60 Chandler Hwy, Alphington

This peer review of the MEL Consultants Environmental Wind Speed Measurements report (Report 174/19-WT-ENV-00) is based on Vipac's experience as a wind-engineering consultancy.

Review of the environmental wind speed measurement report

Figure 1: Test Locations

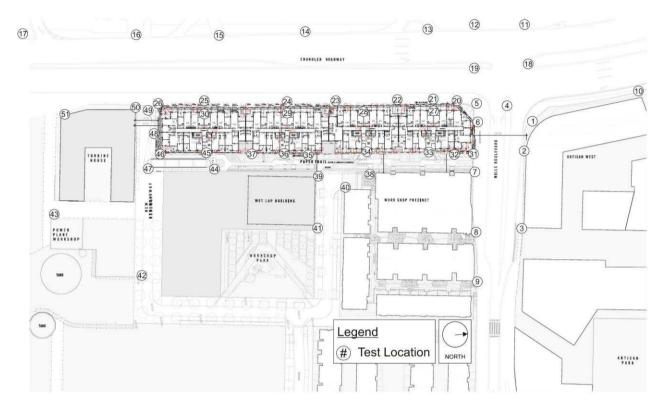
- We have no issue with the criteria for wind environmental conditions developed by MEL Consultants, which was adapted in this report.
- In the Model and Experimental Techniques section, a 500 m minimum radius proximity model was used and is substantially sufficient. The Category 3 exposure was used in the assessment; this was also appropriate. Hot wire anemometers were used to measure the local wind speeds at various particular locations for the ground level (see Figure 1 in the attachment).

Figure 2: Level 4 plan

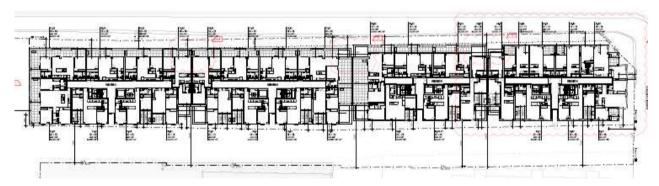
Vipac notes that, at Level 4, the two open balconies between Buildings B and C are quite large (about 50 m² each, see Figure 2 in the attachment) and the wind conditions at all balconies including these large balconies have not been assessed in the report. It would be acceptable if the authority only requires ground level wind conditions be assessed for town planning purposes. However, Vipac recommends the wind environment in these large balconies areas should be considered, at least via a desktop assessment, and meet walking criterion as a minimum.

Vipac recommends MEL Consultants to provide an assessment to the large balconies on Level 4 between Buildings B and C.
